REF: CFH
DRAWING

CMS_FEH_6_OB_EC_POS
2

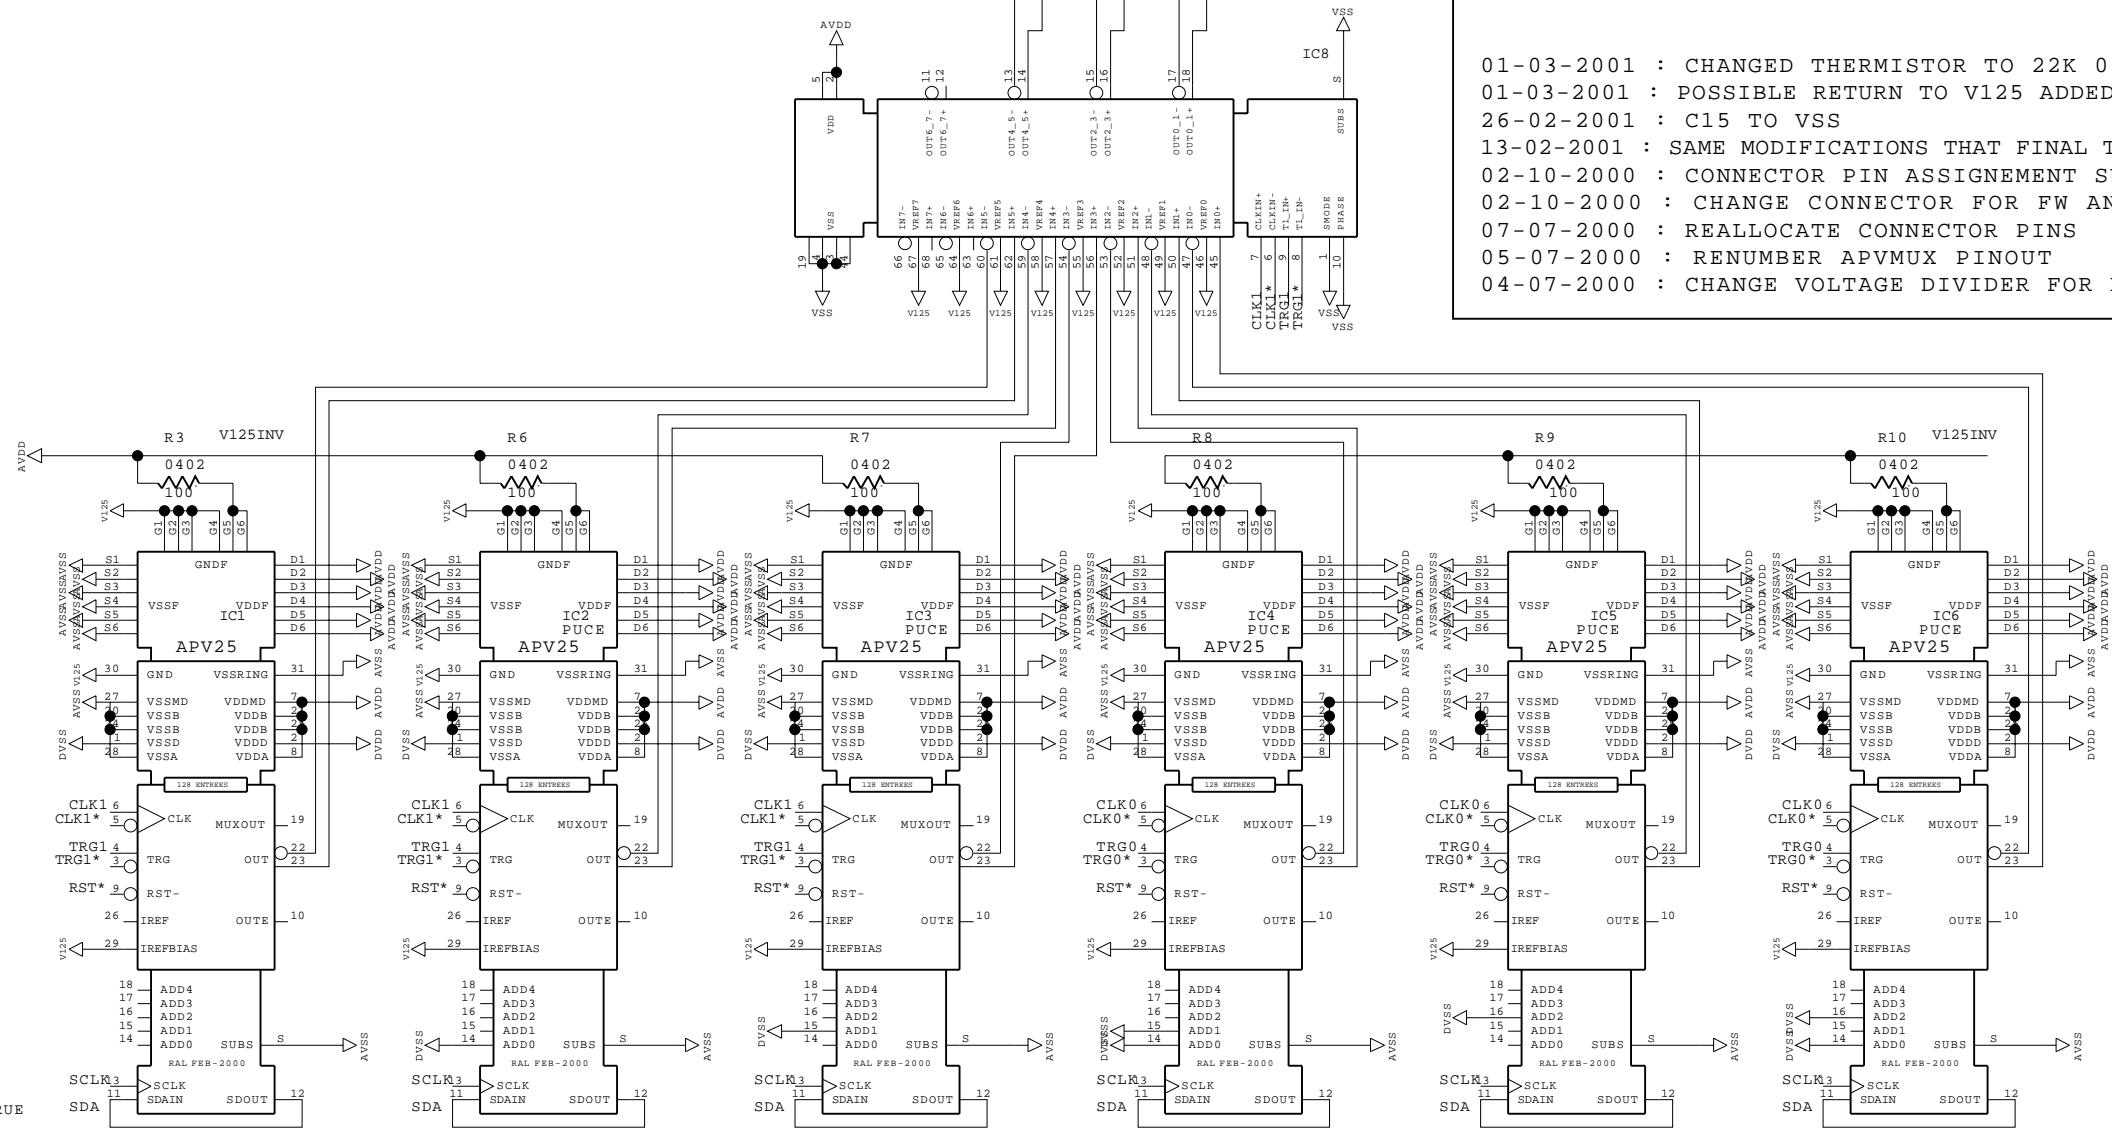
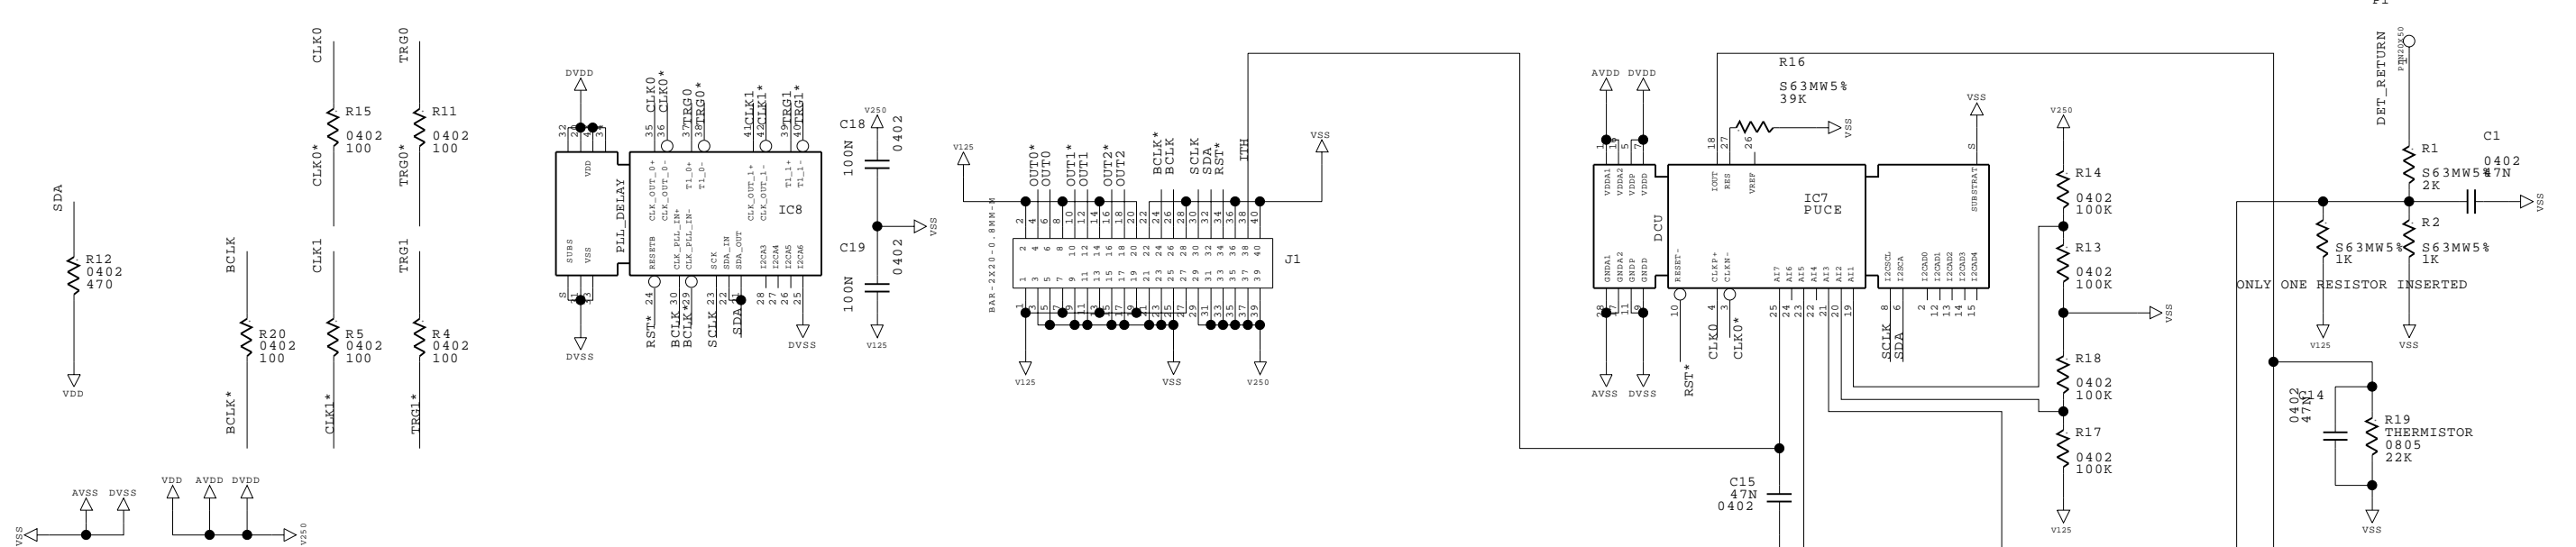
- 01-03-2001 : CHANGED THERMISTOR TO 22K 0805
- 01-03-2001 : POSSIBLE RETURN TO V125 ADDED FOR TEST
- 26-02-2001 : C15 TO VSS
- 13-02-2001 : SAME MODIFICATIONS THAT FINAL TIB
- 02-10-2000 : CONNECTOR PIN ASSIGNMENT SUBJECT TO CHANGE
- 02-10-2000 : CHANGE CONNECTOR FOR FW AND OB
- 07-07-2000 : REALLOCATE CONNECTOR PINS
- 05-07-2000 : RENUMBER APVMUX PINOUT
- 04-07-2000 : CHANGE VOLTAGE DIVIDER FOR DCU
